**NSLPP MEETING HELD ON 06/09/23  
SECTION 4.55 (1a) APPLICATION REPORT**

**ADDRESS/WARD:** 30 Myrtle Street, North Sydney

**APPLICATION No:** DA279/21/2

**PROPOSAL:** To modify a consent to delete Condition C14(c) pertaining to the east-facing windows in the first floor master bedroom and to amend Condition C14(d) pertaining to the reduced balcony width, and extension of approved sliding doors, addition of two (2) skylights on the ground floor and deletion of window (W-03) in first floor bedroom

**Figure 1: Proposed east elevation showing changes to balcony (circled in red) and windows (circled in purple) in master bedroom (first floor)**

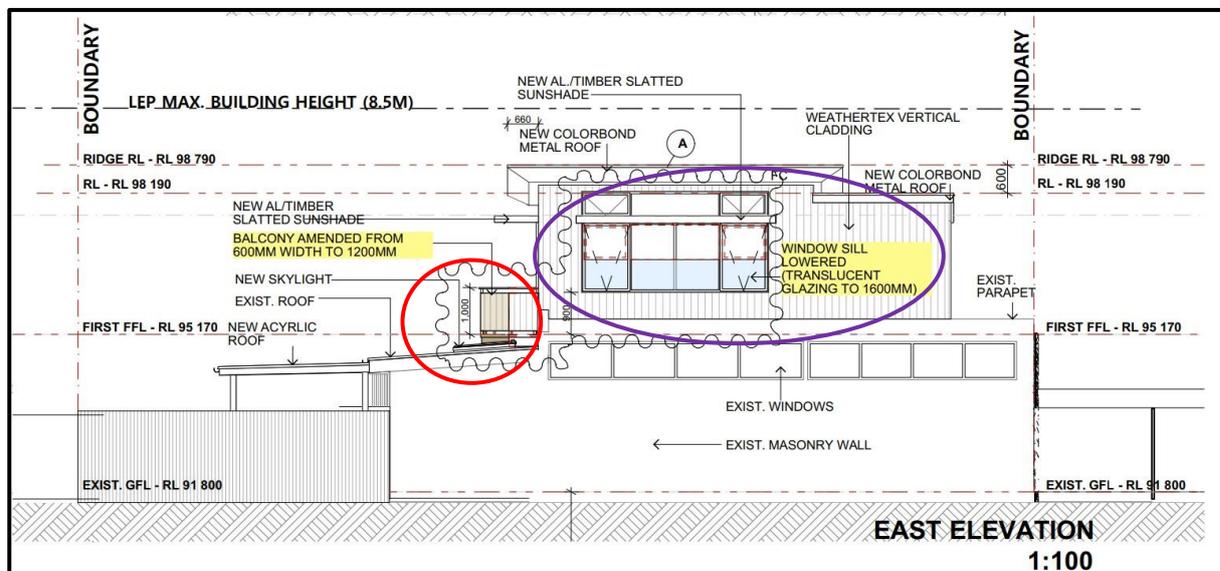
Council imposed this conditional requirement to minimise potential overlooking from the master bedroom. It is noted that this space will receive ample daylight and ventilation through windows and openings facing west and south. Modifying the elongated east-facing windows to highlight windows would not substantially affect the amenity of this space. Notwithstanding, the Applicant proposed to delete this requirement and instead, impose amendments to these windows to comprise frosted glass to 1.6m sill height (measured from the finished floor level) and that all openable window panels (on the eastern side) would be awning-style, with a restricted opening of 125mm (refer to Figure 1).

It is noted that Council imposed a conditional requirement to have a solid form balustrade for the balcony in order to minimise potential overlooking from the master bedroom and balcony area. The NSLPP on 2 February 2022 amended this conditional requirement and imposed a further change to the balcony to reduce its width (depth) from 1.2m to 0.6m (600mm). The subject application seek approval to amend Condition C14(d) and delete the requirement imposed by the NSLPP that reduced the balcony depth (refer to Figures 1 and 2).

- c) ~~Change the windows~~ **Windows** in the main bedroom **along the east facing elevation are to feature translucent glazing to a 1.6m height (measured above the finished floor level) and all operable window panels (on the eastern side) must be awning-style, with a restricted opening of 125mm.** ~~a highlight window with a minimum sill height of 1.6m above finished floor level.~~

- d) Modify the first floor bedroom balcony to have a ~~depth of 600mm and~~ **balustrades** ~~balustrade~~ with a solid form that is designed to reasonably maintain amenity for adjoining properties.

Figure 4: Proposed south elevation – additional sliding door incorporated in area (circled in green)

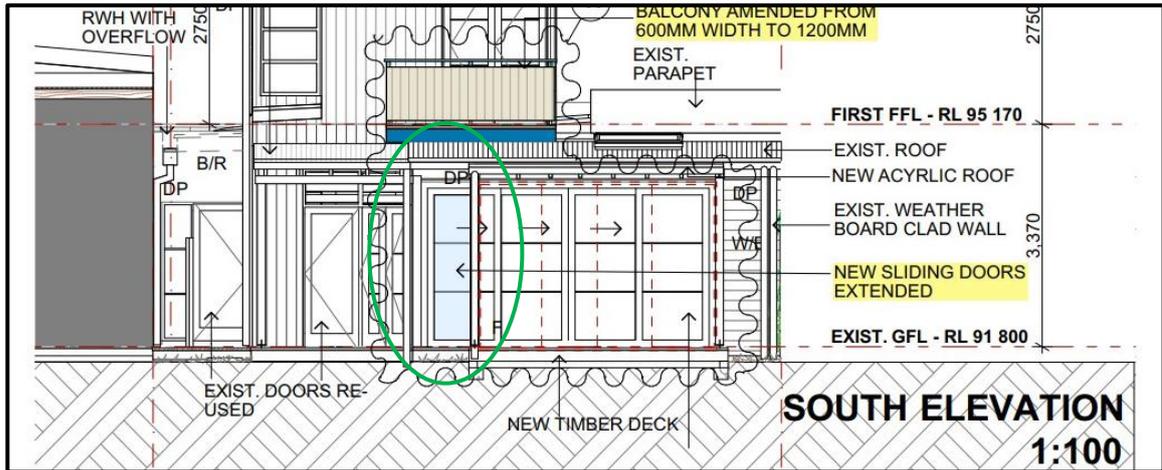
- Extend the approved sliding doors D-01 and D-02 to the corner, within the living room (refer to Figures 3, 4 and 6).

Figure 5: Site plan showing new skylights (circled in dark blue)

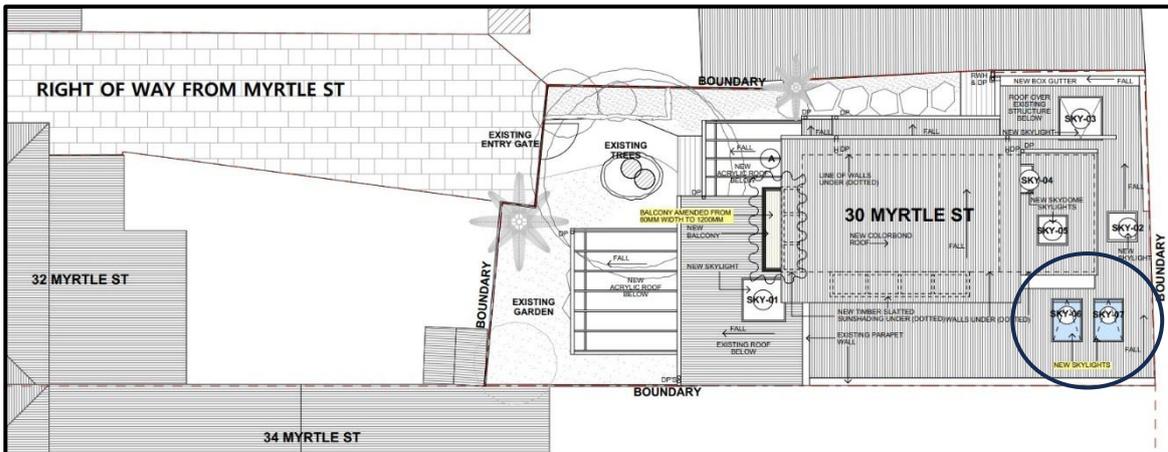
- Installation of two (2) skylights above the approved bedroom 3/study (refer to Figures 5 and 6).

Figure 7: South elevation showing deletion of window and relocated balcony door (outlined in orange)

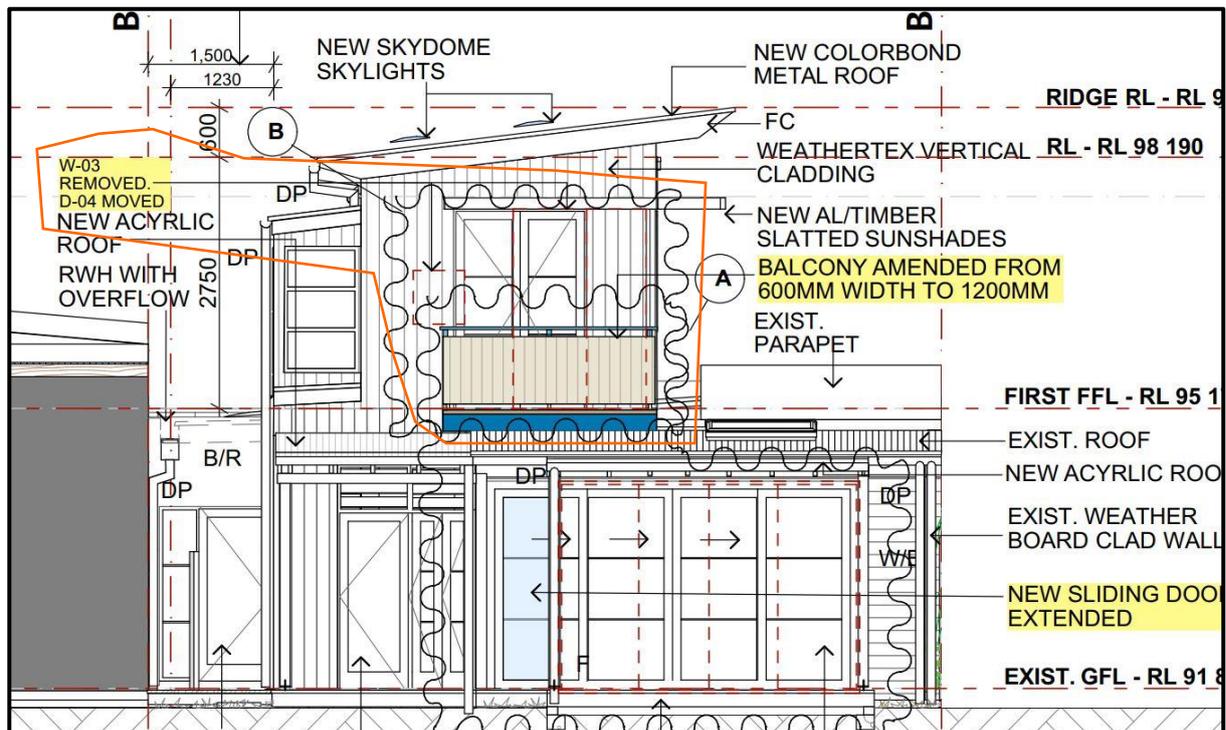
- Deletion of small south-facing window (reference W-03) and re-location of balcony doors (reference D-04) in master bedroom (first floor) (refer to Figure 7).
